Determination 2021/027

Regarding the authority's refusal to grant building consents for the construction of new residential dwellings at 66, 66A and 66B Elizabeth Street, Tuakau

Summary

Figure 1 – site plan (not to scale)

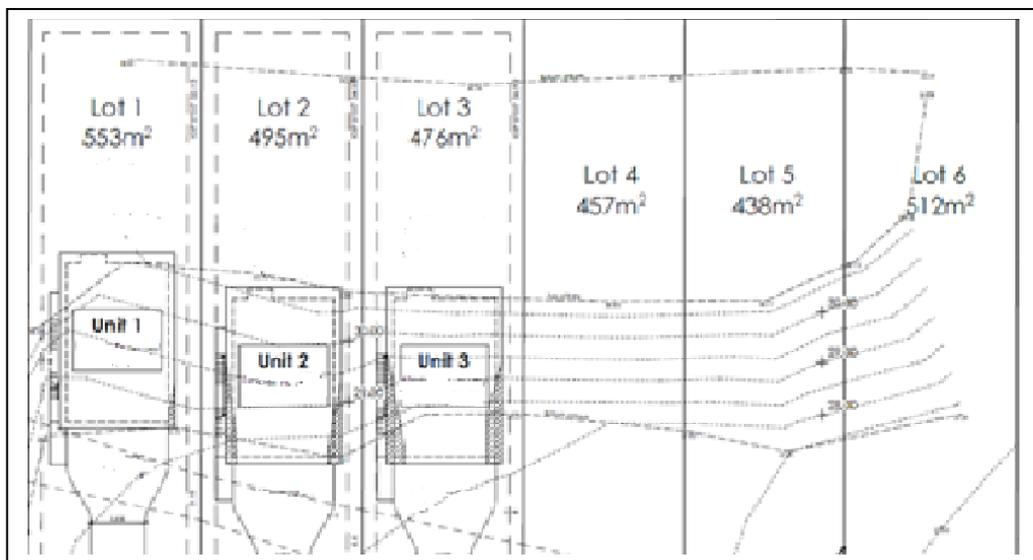
- In respect of building consents for properties at 66, 66A and 66B, the request stated:
- E1
- Supply a suitable stormwater design from a registered engineer as per the recommendations of the [geotechnical report] and [the consent notice].

- 3.10.1 The authority requested the owner “supply a suitable stormwater design from a registered engineer as per the recommendations of [the geotechnical report] and the [resource] consent notice”.

- 5.9 The owner considers a design for the stormwater management system has been provided using the recommendations of the geotechnical report, and the geotechnical report contains calculations and design information.
- 5.10 Drawings, specifications and calculations were provided to the authority in support of the building consent applications under section 45 of the Act. However, the authority limited its consideration of the proposed stormwater design to the requirements of the resource consent notice instead of identifying any non-compliances of the design with the performance requirements of Clause E1. If the authority has specific concern with compliance, it should have identified that concern and related it to the requirements of Clause E1 rather than requiring adherence to a resource consent notice.

Figure 2 – Photograph of the western site cut

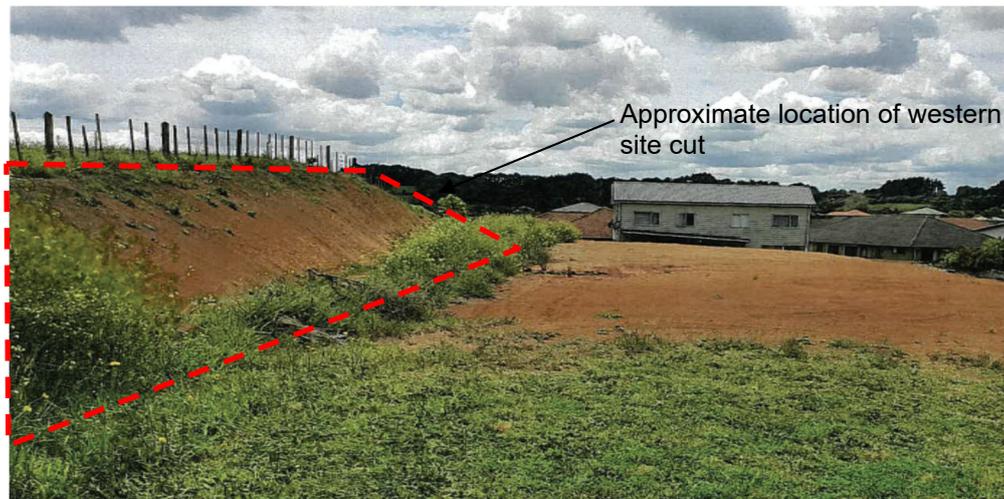
There is a site cut on the western boundary behind Lots 2, 3, 4, and 5. This site cut is starting to fritter and shall need retaining. A retaining wall can be designed with the parameters mentioned within this report.

- B1
- Review [geotechnical report] and requirements for retaining wall to be designed and constructed on the western [site cut]. Engineers (sic) design required.

- 3.10.2 The authority requested the owner “review [the geotechnical report] and requirements for a retaining wall to be designed and constructed on the western [site cut]”. The authority went on to say an engineered design was required.

- The geotechnical report stated “the [western] site cut is starting to fritter and shall need retaining”.
- The statement that the western site cut shall need retaining “is not ambiguous in the slightest [and] it would be negligent of the [authority] to ignore this

- 5.11 The authority considers it cannot ignore the fact the geotechnical report states the western site cut is starting to fritter and needs retaining. It says it cannot ignore this because it has a “duty of care”. It considers the frittering of the bank needs to be addressed by way of further information, or a retaining wall design, as part of the building consent applications.

- 5.12 The owner considers the western site cut is not relevant to the building consents as it is 17.19m from the closest proposed new dwelling as per the building consent plans. Additionally, while the western site cut will require retaining in the future, this does not necessarily mean retaining works need to be done presently.

- 5.15 In my opinion, the 17.19m distance from the nearest building is relevant to the appropriateness of the council’s requirement. No specific compliance concern has been raised by the authority. I note also that the location of the building sites are:

- not within close proximity to the western site cut, and therefore the site cut would not cause structural stability issues for the proposed buildings or expose them to any risk from potential erosion.

- 5.16 I therefore consider it was incorrect for the authority to request further information about the western site cut on solely on the basis that it has a duty of care. The
